# Memorandum

March 1, 2023

**Re: Revised Additional Depth of Contamination Characterization Addendum within the Gasco Sediments Site Project Area**

**Figure 2**  
**Proposed Subsurface Depth of Contamination Refinement Cores and Riverbank Angled Borings**  
 Revised Additional Depth of Contamination Characterization Addendum Within the Gasco Sediments Project Area  
 GASCO0049504

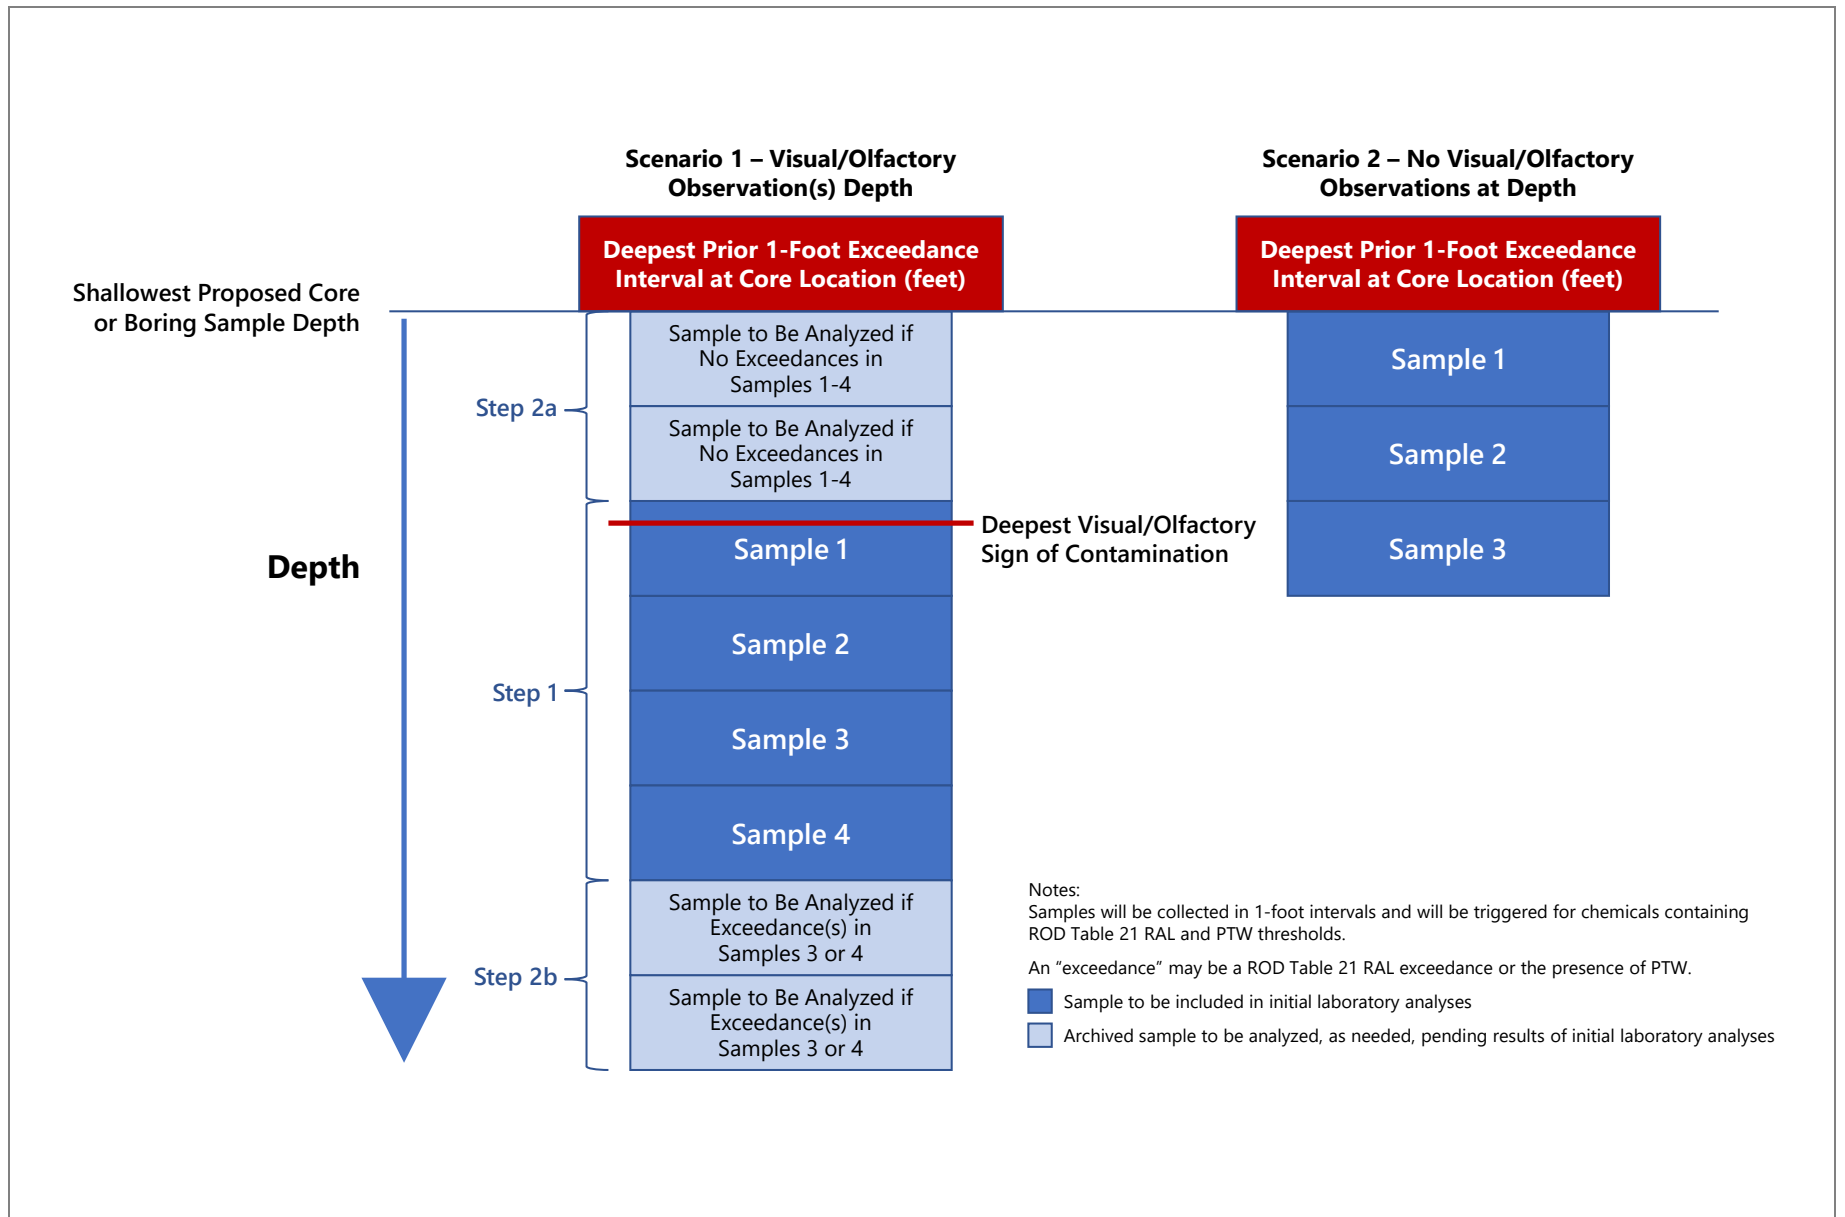
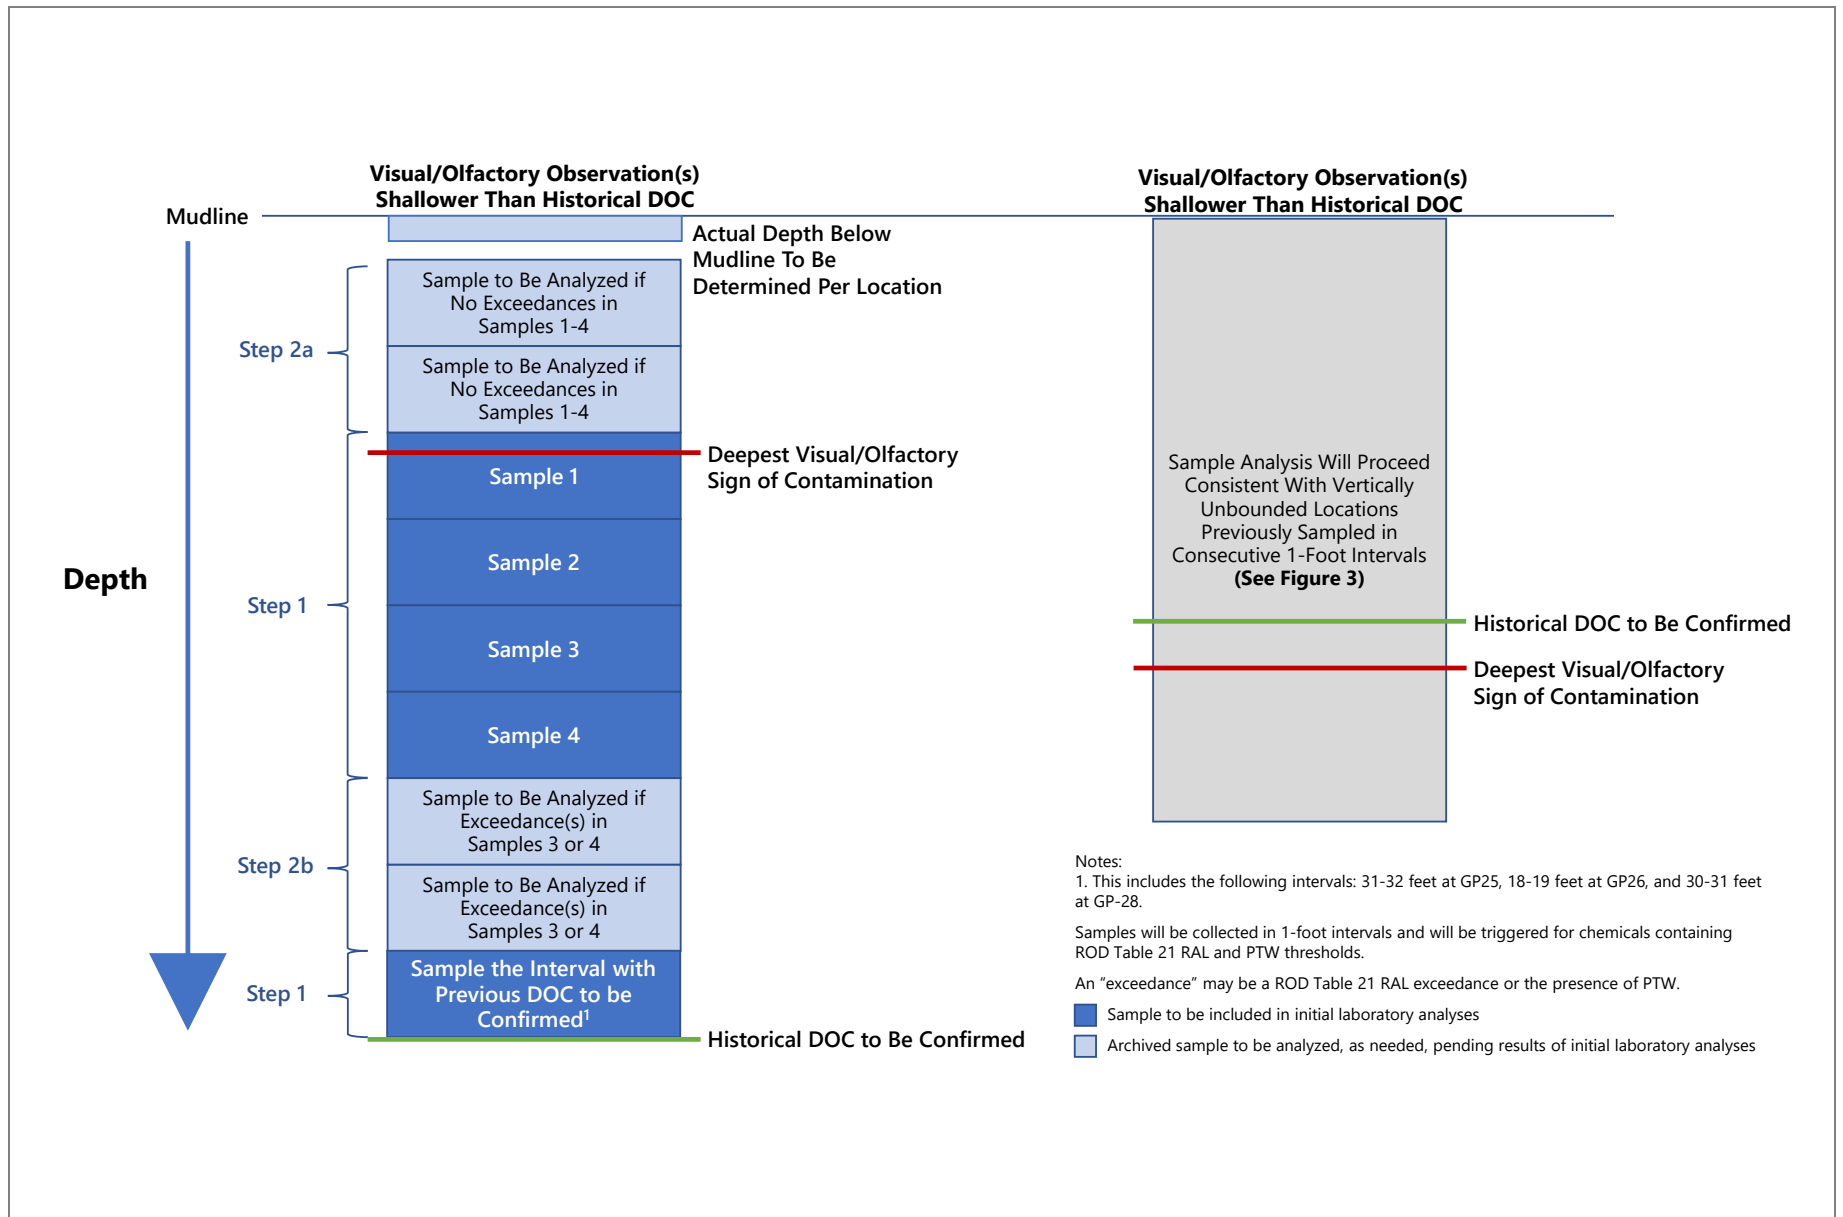
**Contingency Cores:** The intended purpose of the contingency coring locations PDI-212 and PDI-213 included in Figure 2, Figure A-2, and Table A-1 should be discussed in the main DOC Addendum text, along with the criteria to be used to trigger sampling at these locations.
